HISTORIC AND DESIGN REVIEW COMMISSION

November 02, 2016

Agenda Item No: 9

HDRC CASE NO: 2016-418
ADDRESS: 600 LONE STAR BLVD
LEGAL DESCRIPTION: NCB A-17 BLK LOT E IRR 942.92 FT OF 17
ZONING: IDZ H RIO-4
CITY COUNCIL DIST.: 5
DISTRICT: Mission Historic District
APPLICANT: Adam Schneider/Aqualand Development
OWNER: Lone Star Brewery Development, Inc.
TYPE OF WORK: Conceptual approval of the redevelopment of the Lone Star Brewery
REQUEST:

DEMOLITION PLAN

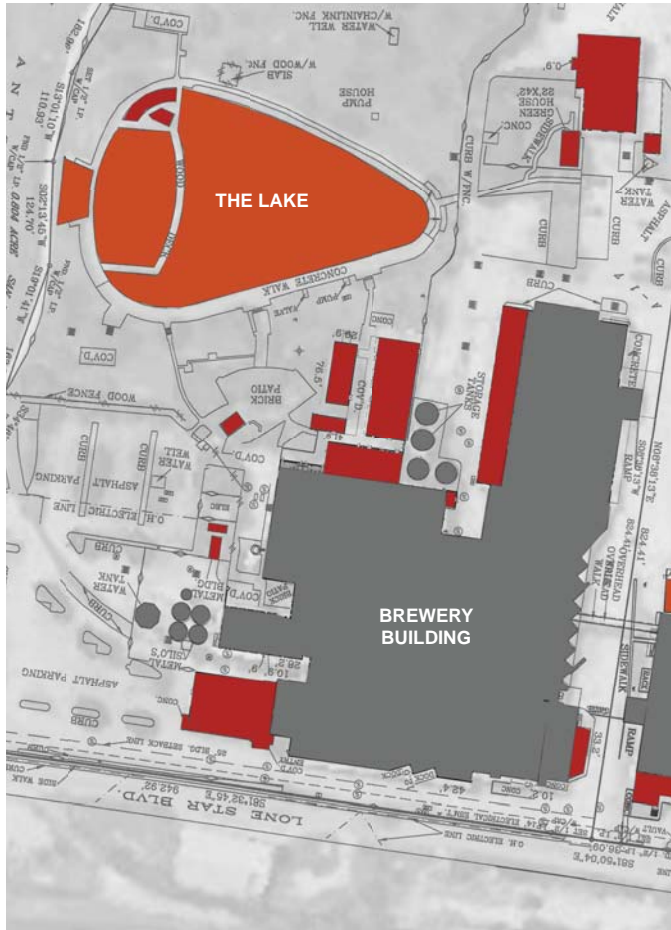
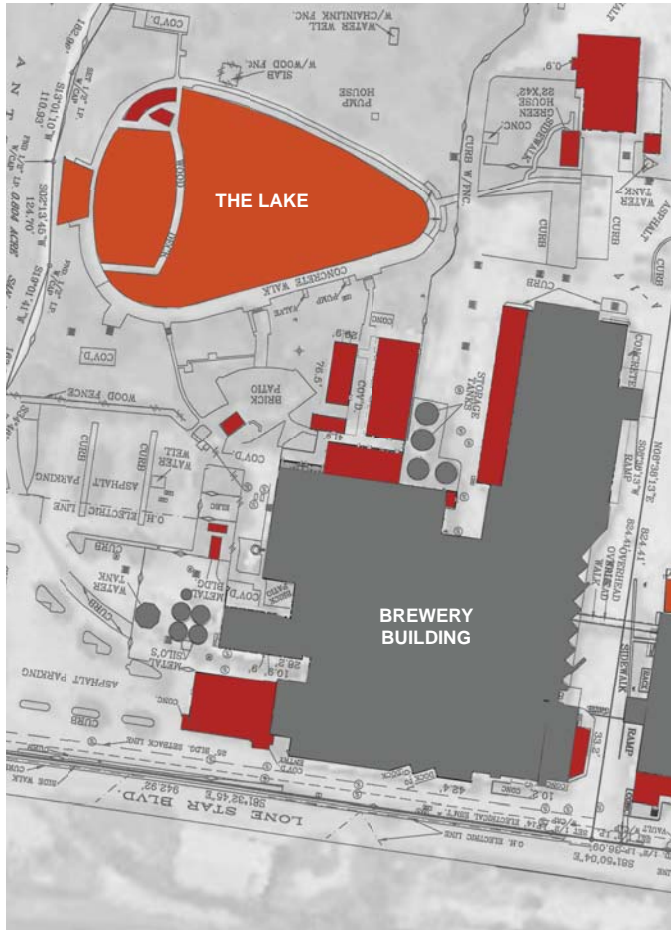
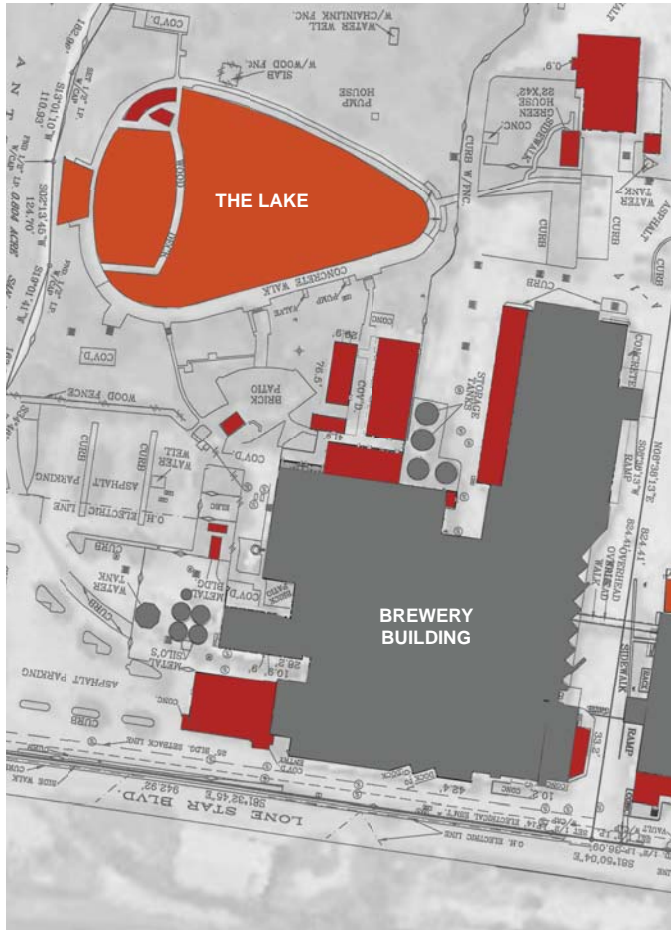
- e. **PARTIAL DEMOLITION** – At this time, the applicant has proposed to partially demolish portions of the Cannery Building, located west of the Brewery Building. Along the west property line, the applicant has proposed to demolish a portion of the warehouse constructed circa 1970 to facilitate vehicular access to the rear of the site. Along Lone Star Boulevard, the applicant has proposed to demolish the one story office structure that is located between the surface parking lot adjacent to Lone Star Boulevard and the two story portion of the Canner Building. Both of these structures were constructed in the 1970's and do not hold historic significance that relates to the Brewery. Staff finds the proposed demolition of both of these structures appropriate.

- f. **PARTIAL DEMOLITION** – In addition to partial demolition at the Cannery Building, the applicant has also proposed to partially demolish portions of the Brewery Building including truck storage, an existing garage and loading docks. These structures are located at the rear of the Brewery Building with the exception of building 7, which is located along Lone Star Boulevard. Building 31 was constructed circa 1965, exhibits low architectural

- g. **PARTIAL DEMOLITION** – Regarding the demolition of structure 32, elements of significance include an interior mural which depicts many architectural and cultural icons of San Antonio in the form of a timeline. The addition itself was constructed circa 1950. Modifications to this structure have occurred in the past including the removal of the west wall and modification to the mural including the majority of it being painted over. Staff finds the demolition of this structure appropriate.

THE LAKE - ENLARGED PLAN VIEW (NTS)

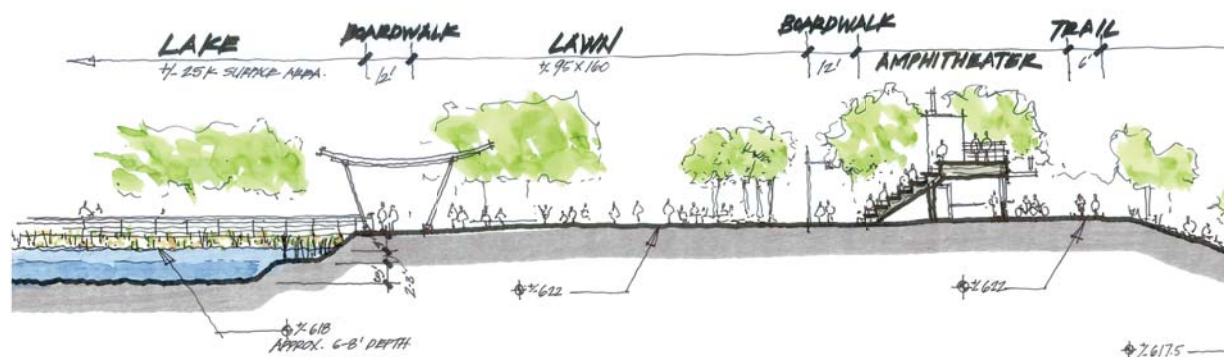
- j. **LAKE** – To the east of the Brewery Building, the applicant has proposed to repurpose the existing lake. The general shape of the lake will be maintained; however, the applicant will modify the area of the lake which holds water as well as modify the lake's depth. The applicant has proposed to incorporate plantings that are native to San Antonio. Staff finds the applicant's proposal appropriate; however, staff recommends the applicant install a design feature which clearly shows the lake's original shape.

COMMENTS/CONCERNS: BE: QUESTIONS OVER THE EXISTING POOL/POND.

- i. That the applicant incorporate a design feature into the proposed new lake design which clearly shows the lake's original shape.
- ii. That the applicant coordinate with the San Antonio River Authority regarding landscaping and maintenance boundaries and storm water control measures.
- iii. Archaeological investigations are required. The archaeological scope of work should be submitted to the OHP archaeologists for review and approval prior to beginning the archaeological investigation. The development project shall comply with all federal, state, and local laws, rules, and regulations regarding archaeology.
